RE: Ferrini Ranch

Subdivision

2.0 RESPONSE TO COMMENTS ON DEIR

Figure 1. Lack of correlation: am average travel speed and traffic volume, 2-lane SR68 (existing conditions)

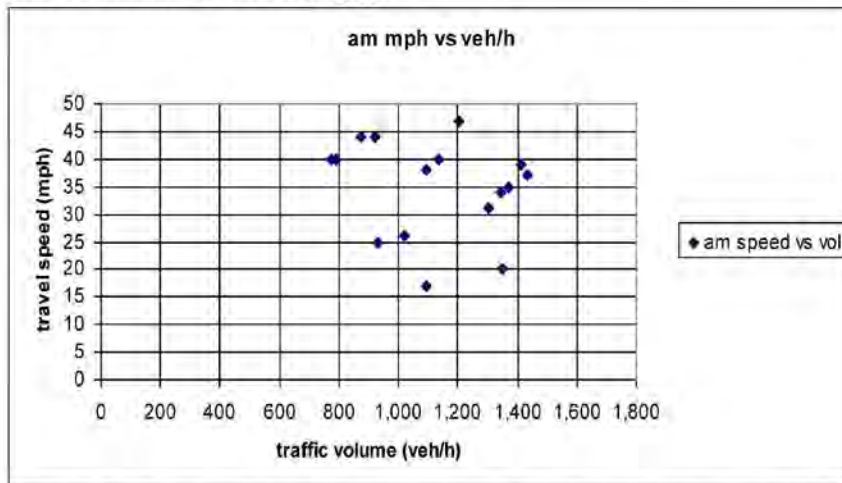
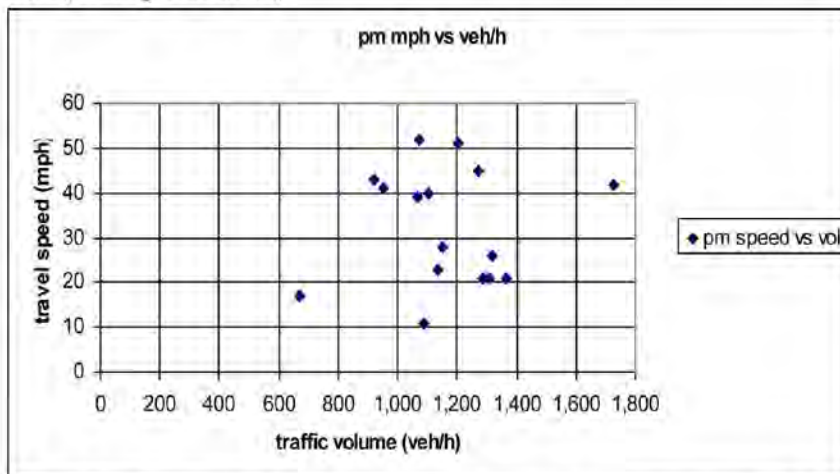
with traffic volume on the relevant road segments, its *reliability in forecasting the effect of additional traffic is negligible.*

We have examined a wide variety (existing, background plus project, background plus project minus existing, cumulative) of plots of travel speeds versus traffic volumes from the relevant DEIR data, and all of these plots have the same general features as those above, in no case showing significant calculated linear or curvilinear correlation between the variables. More detailed examination of the relation between trips added by the project and corresponding differences in travel speed – as reported in the DEIR – shows that the relationships between these variables are not physically plausible.
